URGENT MEDICAL DEVICE CORRECTION NOTIFICATION
URGENT FIELD SAFETY NOTICE

Subject: Potential failure of AlignRT to assert interlock.

Commercial name of product: AlignRT.

Reference/FSCA identifier: 3010769039-15/10/14-001-C (Vision RT reference).

Figure 1: Warning message.

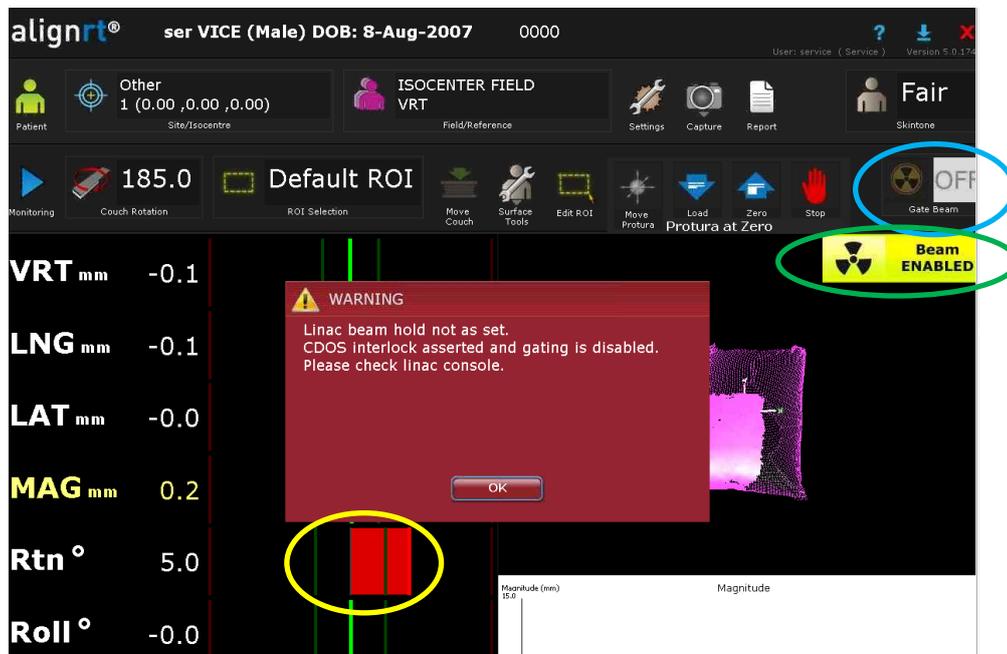
When patient motion that exceeds a pre-set tolerance is detected by AlignRT, in rare circumstances and only for the affected configurations referenced above, AlignRT may display a Warning Message on the main screen (see Figure 1) that states a beam hold interlock has been asserted, when in fact no interlock has actually been asserted on the C-Series Linac. Instead, in such circumstances, the beam will be enabled.

As illustrated below in Figure 1, the issue is readily detectable by the user from the AlignRT User Interface because, in addition to the Warning message, the system correctly shows that the Gate Beam functionality is OFF (blue circle), that the beam is currently ENABLED (green circle), and that the real time deltas are out of tolerance (yellow circle in the example). Additionally, the C-Series console should provide visible and audible indication of the actual status of the beam.

When AlignRT displays this message, the software may no longer be controlling beam delivery on the C-Series Linac, which will continue to deliver dose until manually stopped. If the user does not detect the anomaly and does not take appropriate action in a timely fashion, **the issue may lead to the delivery of an unintended dose of radiation.**

Vision RT has already disabled the MMI interface on all affected devices and did so within 48 hours of identifying the issue.

Vision RT is designing an upgrade that will resolve the issue, and will subsequently contact you in order to install the upgrade on your device. Until the upgrade is available the automated beam-hold function will remain disabled.
